Upgrading to the 21143-PD and 21143-TD

Application Note

November 1998

Figure 1. 21143-TD Package Marking Conventions

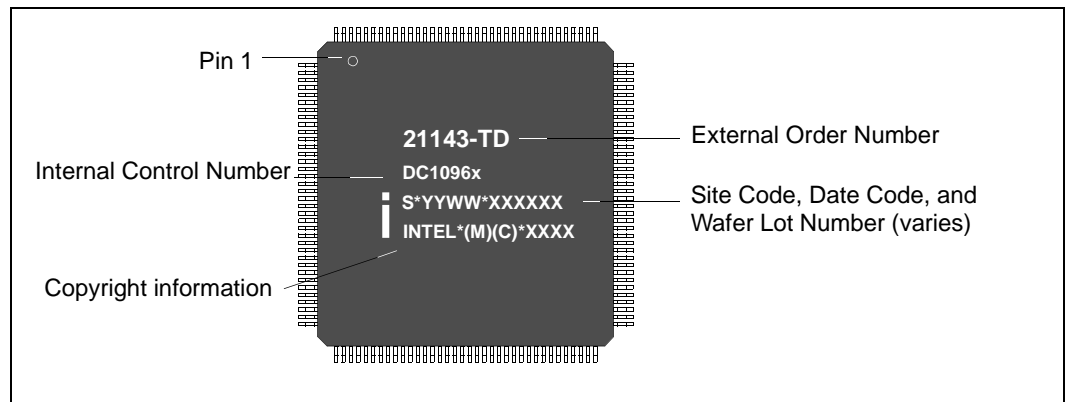
The 21143-TD device uses the following conventions (Figure 1) for package markings.

1. For the 21143-xD, the PQFP package type has been reidentified as the MQFP, and the TQFP package type has been reidentified as the LQFP. This was done to conform to industry standard. The physical characteristics are the same for both package identifiers.

Figure 2. 21143-PD Package Marking Conventions

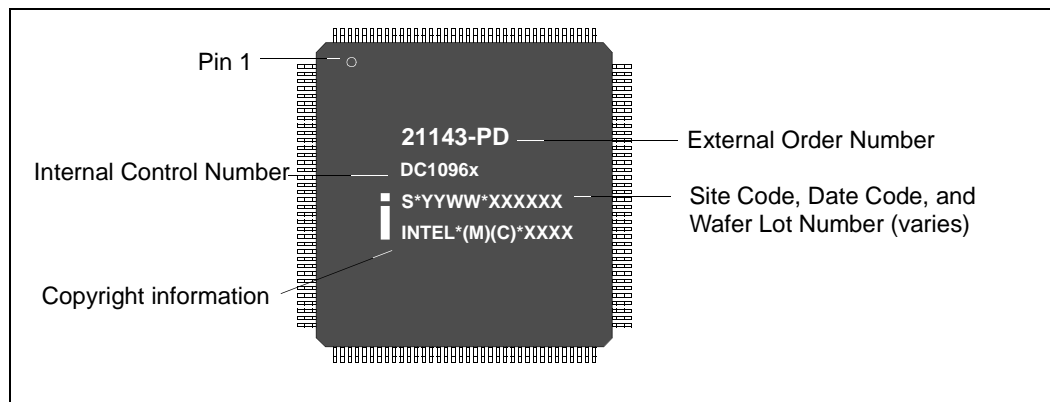
The 21143-PD device uses the following conventions (Figure 2) for package markings.
